Access Compliance Report Public Rights-of-Way (Accessible Street Parking)

Intersection ID: 10031761 Main Street: MIDWAY_PARK_DR Location: N/A

ADA ID: D0556329729F ParkingType: ParaPark Overall Compliance: No Severity Score: 0.0

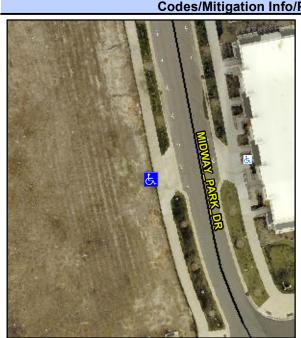
Advise relocating to an area with maximum 2% slopes
